**PROCUREMENT SERVICES
ADDENDUM**

Date of Notice:	1/22/2025
Solicitation No.:	IB-011-25
Title:	JB Speed Student Success Bldg – Landscaping BC-39
Addendum No.:	1

UL Student Success Building

Subject Planting and Irrigation Plans	Date Initiated	Subject (Detailed) Contractor requests more information about soil mix, mulch type, decorative gravel, and landscape edging used in the planting plans. Contractor also requested more information about irrigation.
Initiated By Todd Korfhage (Landscape) Rebecca Johnson (Irrigation)	Date Received	
Response From Tanner Prewitt 1/20/2025	L&F Project Number 2022.091

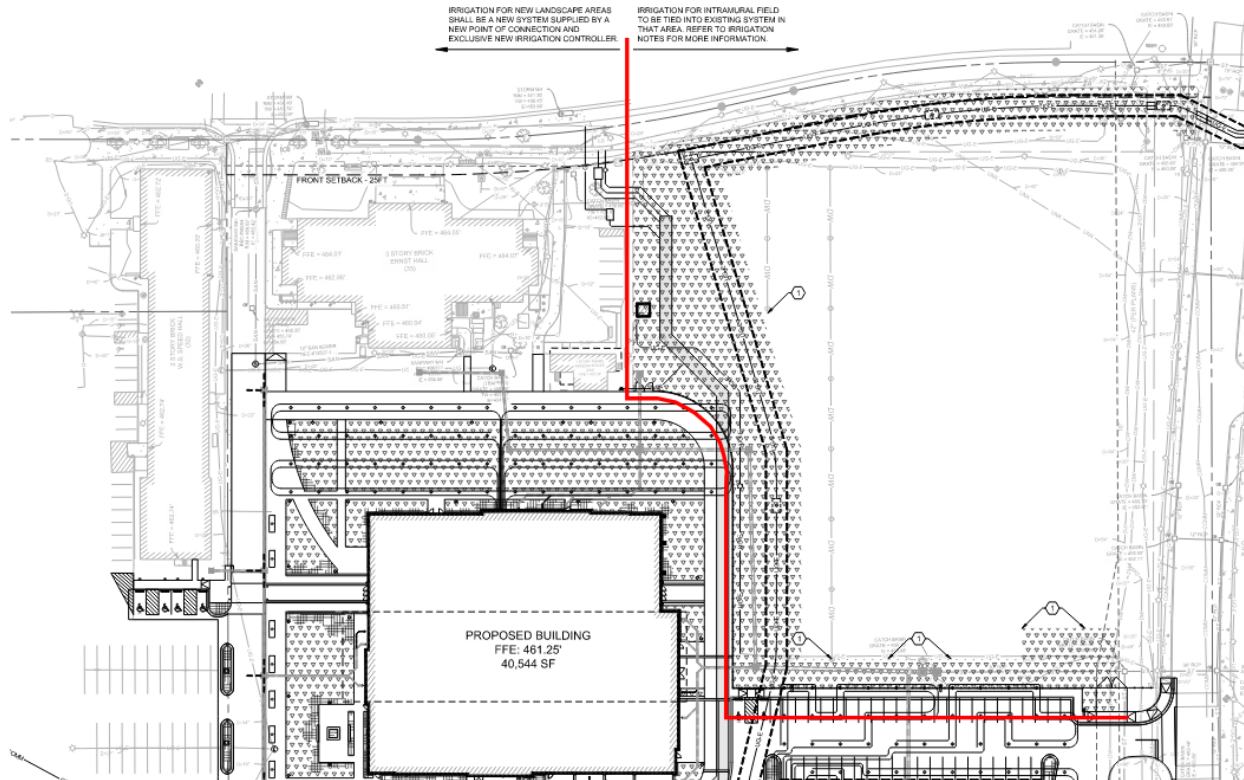
#	Question	Answer	Date
1	What type of soil mix is to be placed in mobile green island planters #1 and #2?	Topsoil is suitable.	1/22/2025
2	What type of mulch is to be used in planters? One note calls for coconut shells to be used and another note calls for Hardwood Mulch to be used.	Per L-203 planting notes, Contractor shall dress soil surface of all planters indicated in the enlargements with a layer of coconut shell chips, minimum 3" thick. The hardwood mulch should only be used in planting beds on the ground surface.	1/22/2025
3	What type of decorative gravel is to be used in the parking area as shown on plan page L-301?	L-301 decorative gravel mulch should be washed river rock.	1/22/2025
4	One Plan page L-301 note #8 - talks about placing and stacking edging. All other notes on plan pages L-201, L-202. L-203 calls for Spade Edging. Which one are we supposed to use?	On L-301, Note #8 in the seeding and mulch notes states: "Contractor shall paint all landscape bed shapes and receive approval from project landscape architect and owner before placing and STAKING edging," not stacking. These edges will still be spade edging, but laying out the curved pattern of some of the planting beds ensures the design is completed as intended.	1/22/2025

Detail 5/L-601 has a planter detail for Streetlife furnishings. Specifically, Section A indicates that the planter must have $\frac{3}{4}$ " minus washed drain rock on the bottom, a layer of geotextile fabric, and planting soil backfill. Topsoil is suitable.

Per L-203 planting notes, Contractor shall dress soil surface of all planters indicated in the enlargements with a layer of coconut shell chips, minimum 3" thick. The hardwood mulch should only be used in planting beds on the ground surface.
